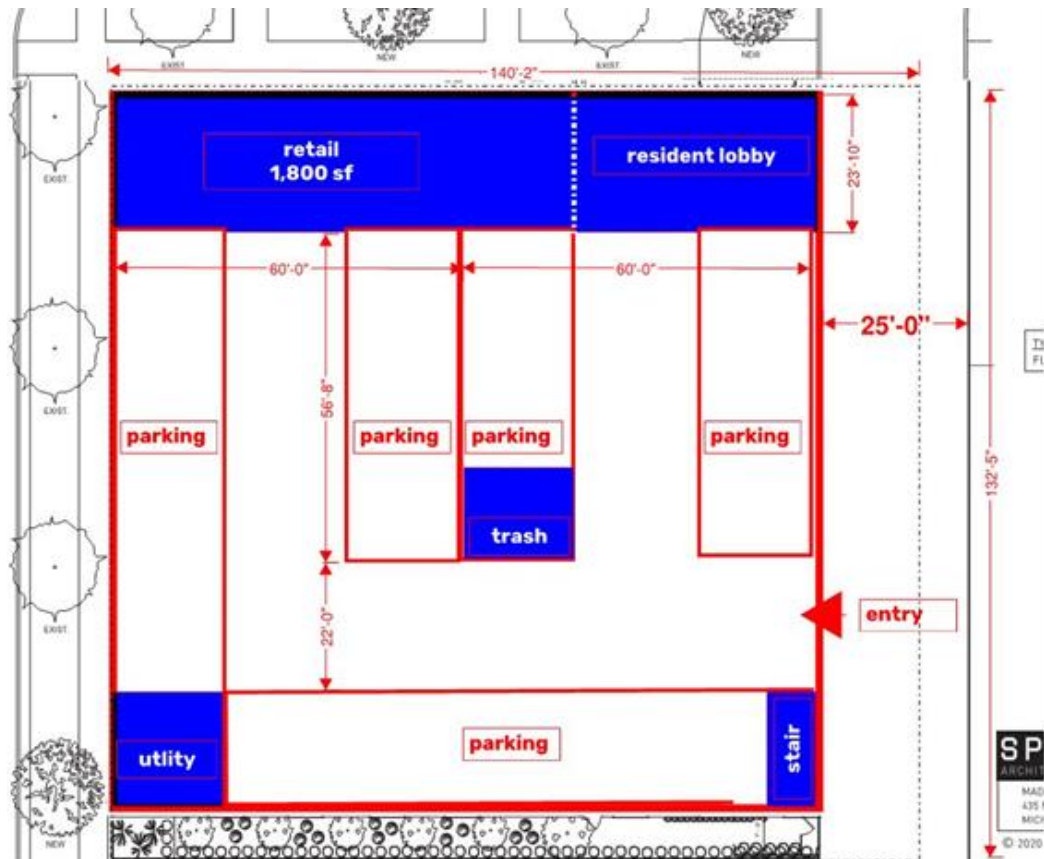
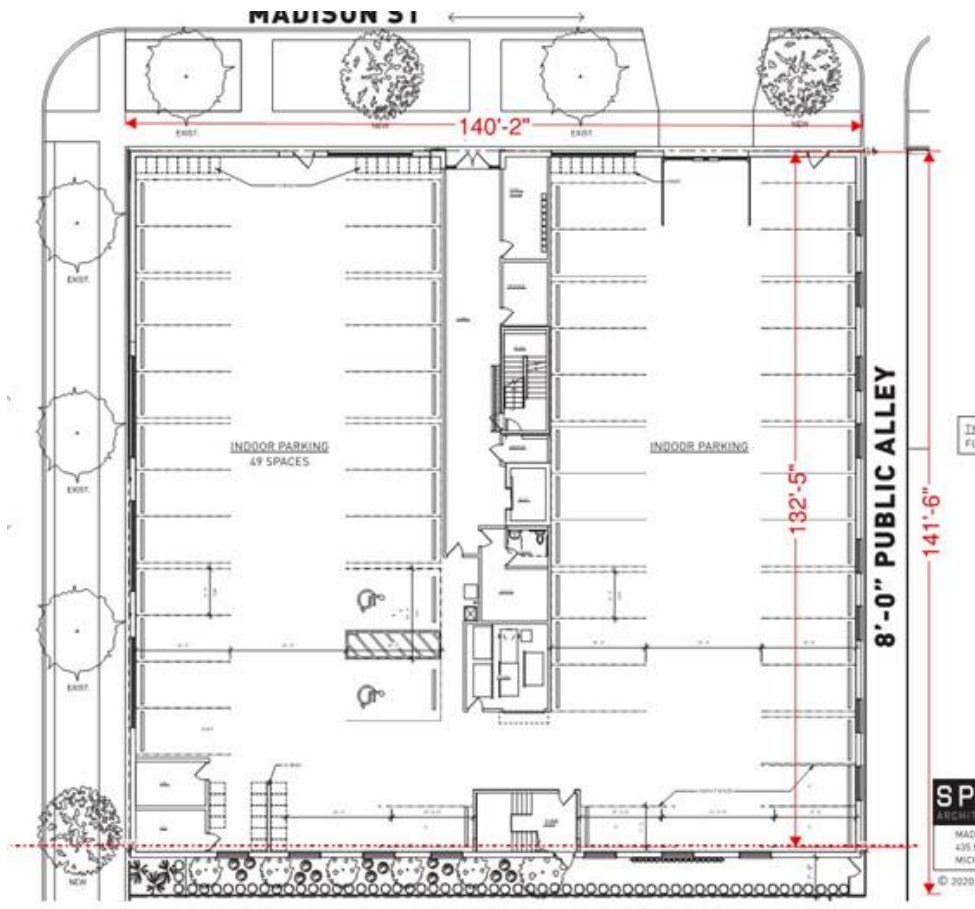
The garbage truck dimensions are incorrectly depicted in the "revised" site plan. It is about 7' too short. In reality, this truck would block alley and garage access if parallel parked as depicted. The same goes for rental moving trucks with ramps down to grade. They architect

They are showing a larger (longer north-south) dimension for the property. The property is 132'-5" (+/-) per civil drawings submitted, but the architect show 141'-6" (+/-) on the garage floor plan. What this means is that, like alot of this design, it was carelessly compiled, not well investigated, and there will be problems down the line. They have exactly 1/1 parking. Given that the garage has to be 9' shorter.. they will be losing 3-4 spaces. Given that the garage is not really able to sustain the required parking, (and the rework required on the unit layouts to comply with the minimum light well requirements i mentioned in my previous email) I think the best thing for the developer to propose is a 4 story building. Create a 25' "rear (alley)" setback to allow for garage entry/loading/ and trash in the alley. Shrink the floor plate and allowing for less units reduces the parking count requirement to more realistically align with the site dimensions. This would allow space for retail along Madison.
